PART 1 AIRWORTHINESS 'AGGRO' (GLIDERS).

Please add these items to the 1977 list of Mandatory Mods and Inspections.

Subject: Aileron control in the cockpit

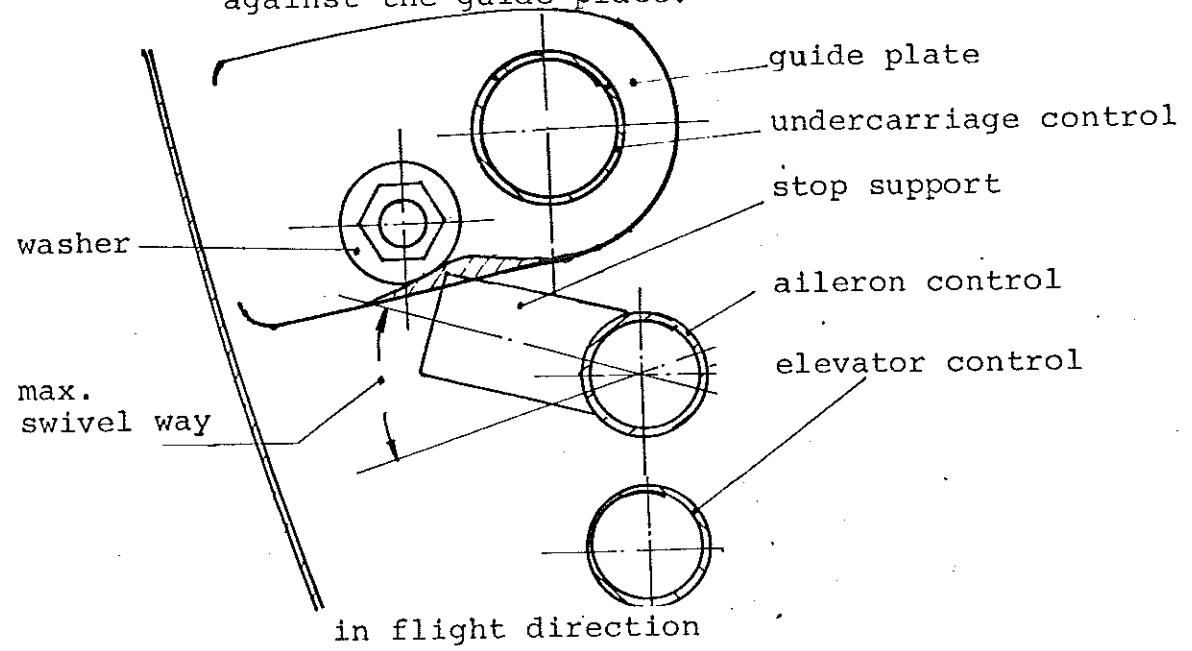
Reason: If the guide plate of the under carriage control push rod is not filed out enough, the stop support of the aileron control push rod may butt against it.
 (Pushrod turned upwards to the most unfavorable position, see figure)
 This might happen during flight conditions under negativ -g- loads.

- Instructions:**
1. Remove the left side covering in the cockpit.
 2. Turn the aileron control pushrod upwards (see figure) and check the stop support for butting against the guide plate.

3. If the stop support push^s against the hatched region of the guide plate, file out this region. If necessary change the installed washer (outside diameter 18 mm) against one with outside diameter 12 mm. (6,4 DIN 125).
4. clean the area of filings
5. reinstall the side covering
6. Book the executed work in your log book.

ADDITIONAL "L" BRACKET TO PREVENT THE WHEEL LOCKING

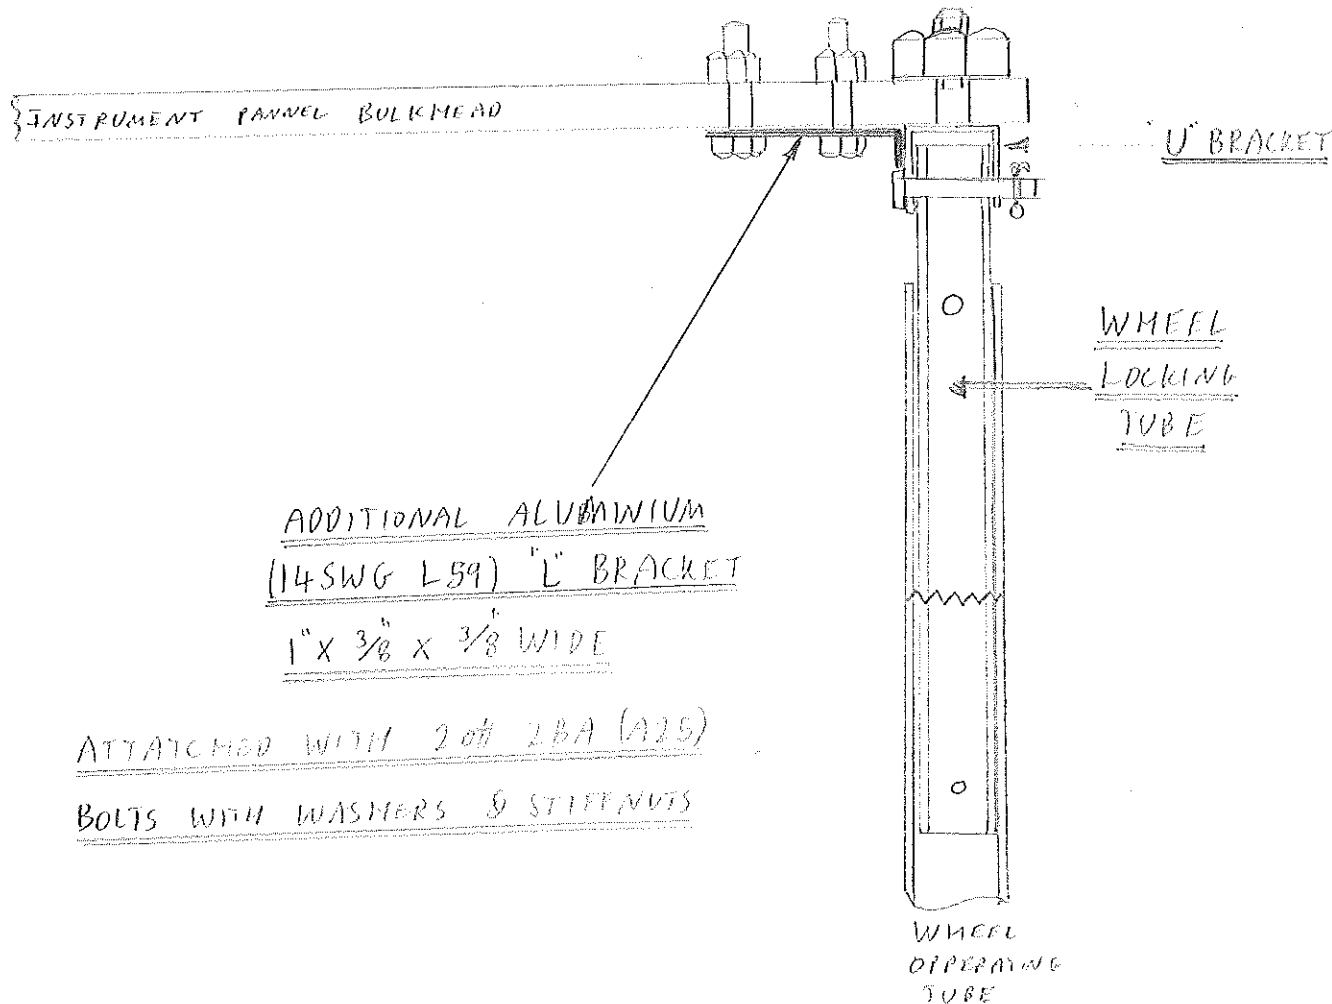
a) Lock failure due to rotation of the wheel locking shaft. Ref sketch by Tim Macfadyen.

The Bracket is mounted hard up against a flat on the locking tube end.

ATTACHED WITH 20# LBA (A25)
BOLTS WITH WASHERS & STIFFNUTS

A neater engineering solution would be to weld a $\frac{3}{4}$ " x $\frac{3}{8}$ " x 16 SWG
steel strip to the "U" bracket that is pinned to the locking tube end
and bolt this to the bulkhead.

JANTAR (STD) U/C LOCKING ASSY. FAILURE TO LOCK.

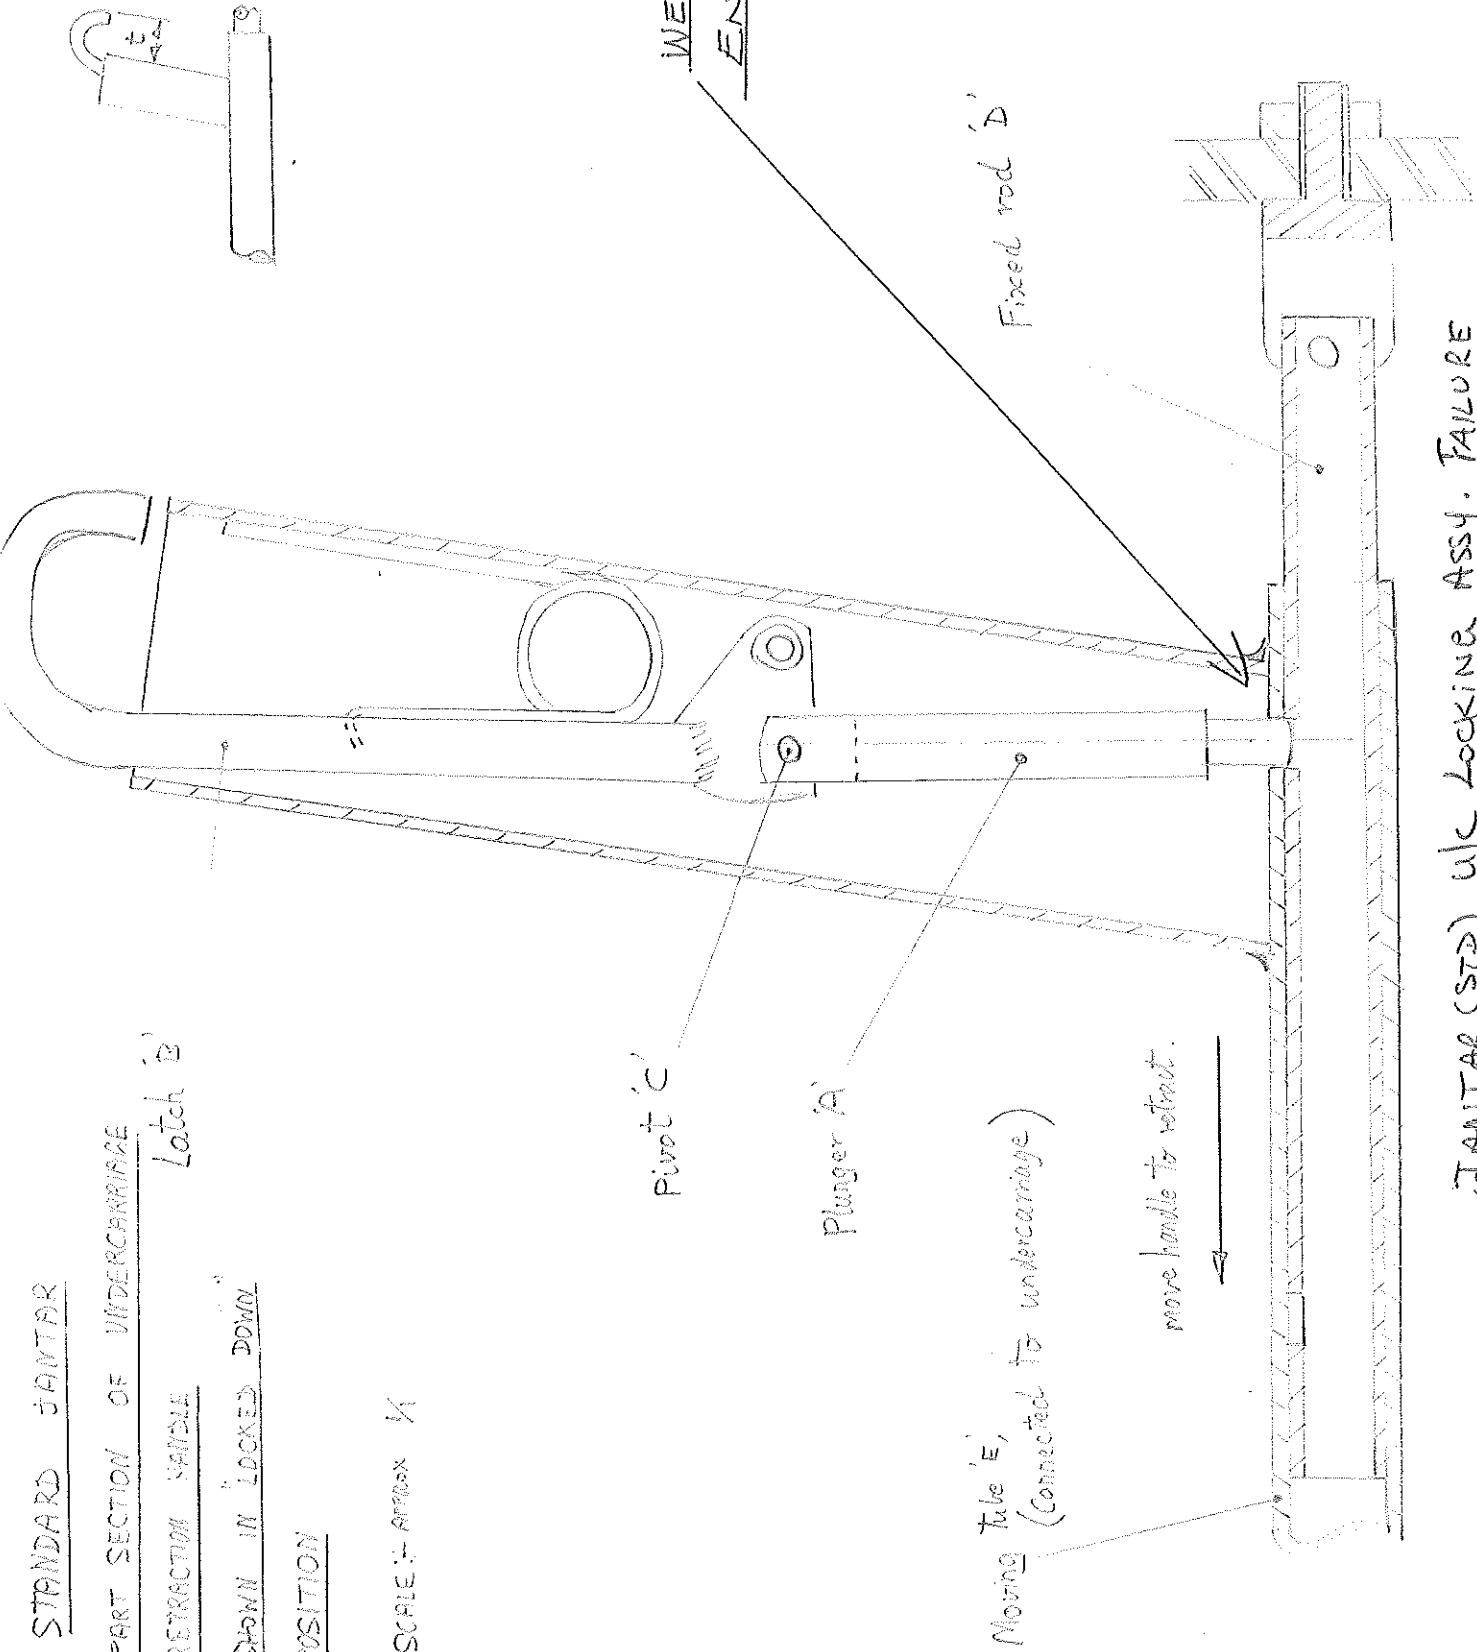
b) Lock failure due to wear etc on locking plunger - Ref sketch by R. Blackmore.

WEAR & LACK OF ENGAGEMENT

T.49 Capstan Rudder Pedal Stop

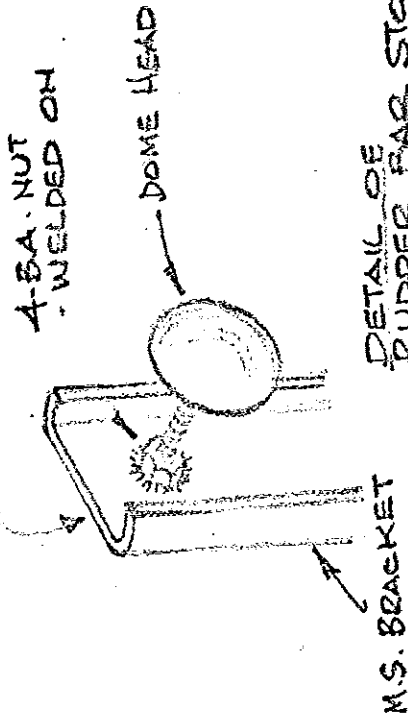
Rudder Pedal Stops - Bent, allowing rudder to lock-over. Ref sketch from Len Morris (Swindon G.C.)

RUDDER BAR
STOP BENT

RUDDER
BAR WEDGED
UNDER STOP

OPEN CIRRUS VTC.
AIR BRAKE QUADRANT.

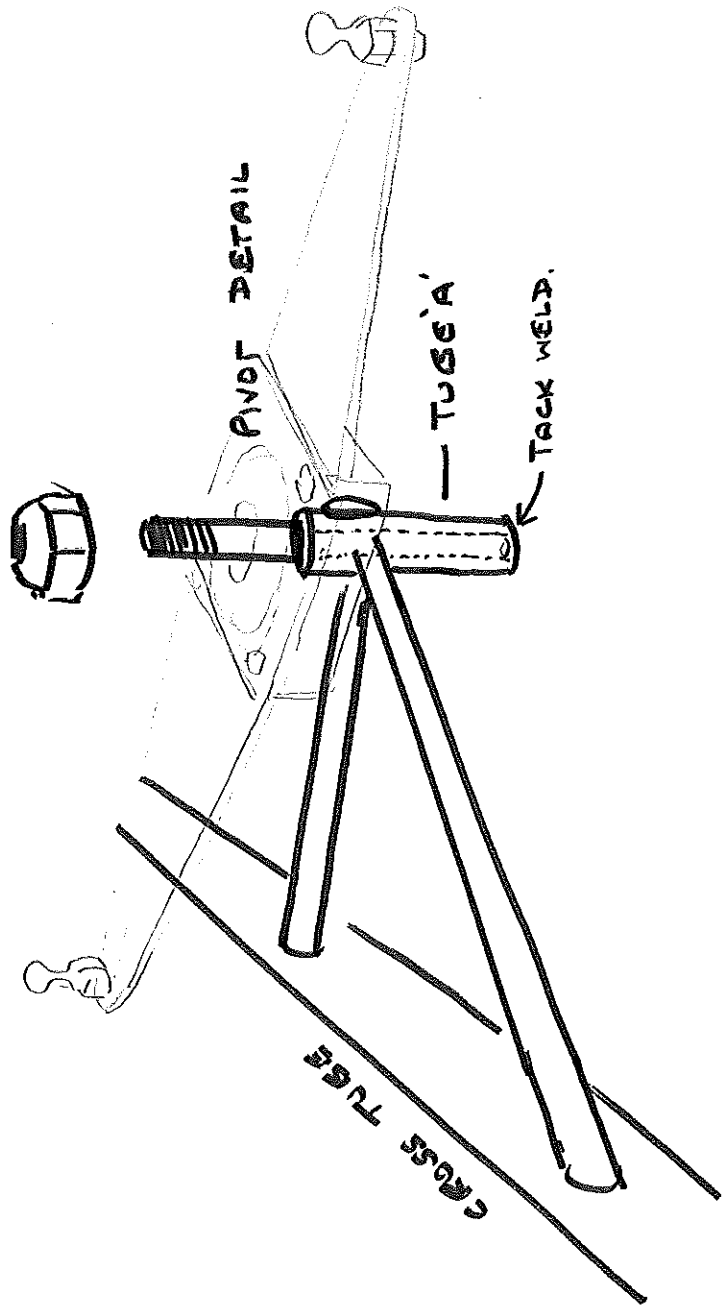
Failure of air brake quadrant pivot. Tack weld failure of stud as indicated in sketch by J. S. Riddock - N.Weald.

- 1/ Quadrant found loose, in up/down plane.
- 2/ Checked nut (self locking), then the stud became free in tube A.
- 3/ Dipped stud out, & find tack weld was once securing stud, as side fixing through tube A was NBS.
- 4/ Cleaned out tube A and inserted bolt as temporary measure.
- 5/ Stud inserted, as can be seen it is bent?
- 6/ Any admin please! - yes - FIXIT! Rhv

2 Drum Blower (PAPERFIL)

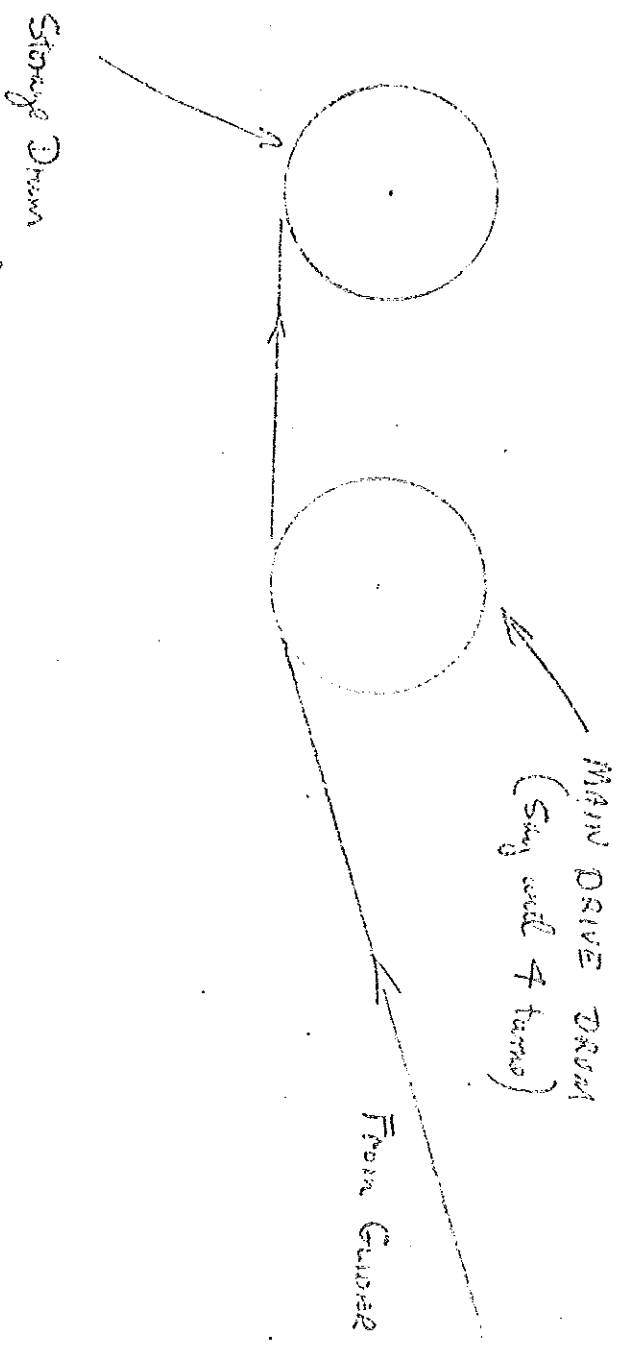
The storage drum would have to be driven by device which limited the torque and therefore the tension on the Parafil Rope. See sketch attached to this letter. Winches of this type have been developed for industrial and shipping uses, although I am not aware of any winch that is suitable size for Glider Launching applications.

- 1) Limited torque
- 2) Surface speed of storage layer would be slightly slower than blower speed if Main Drum because of elastic recovery of rope under lower tension
